Appln. No. 09/594,875  
Amdt. dated May 13, 2004  
Reply to Office Action of February 17, 2004

**Amendments to the Drawings:**

FIG. 6

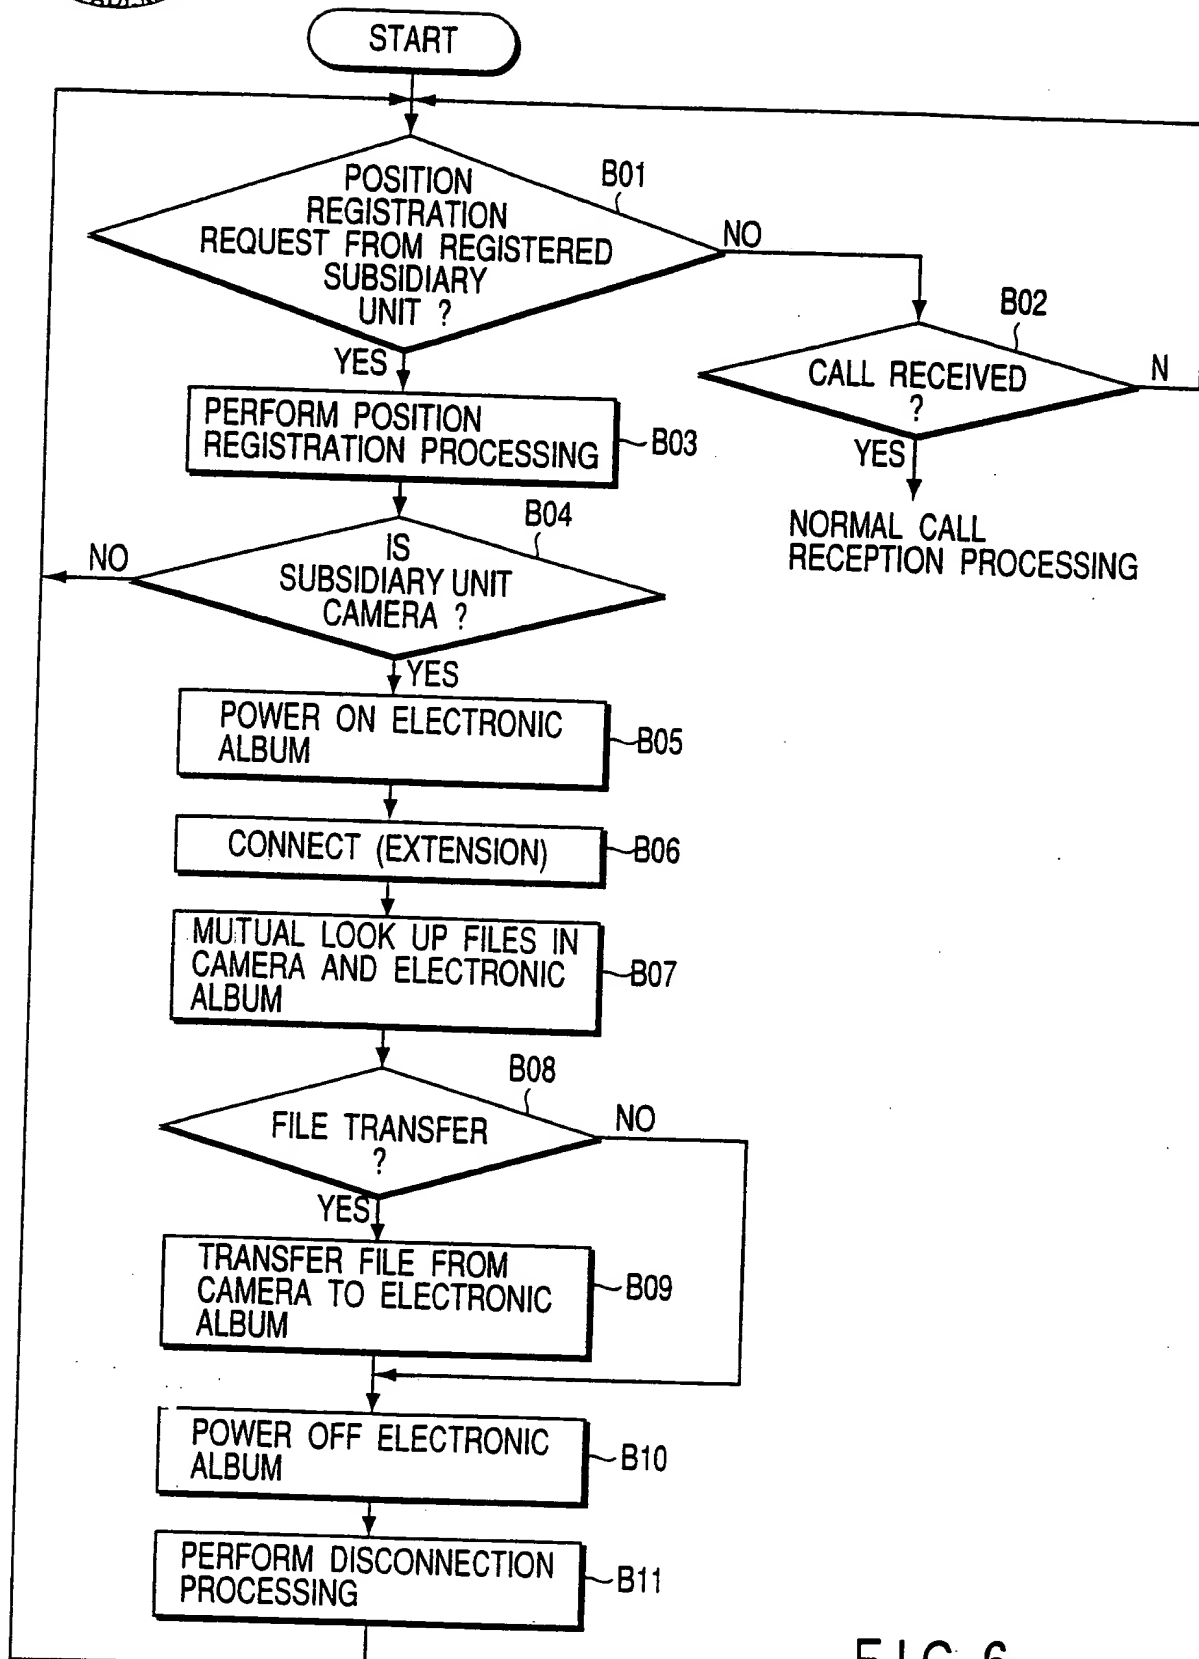
Attached hereto is an annotated sheet showing changes to Fig. 6 and a replacement sheet for Fig. 6. Fig. 6 has been amended to change "munual" in step B07 to -- mutual --. No new matter is added and this amendment is supported by the specification as originally filed.
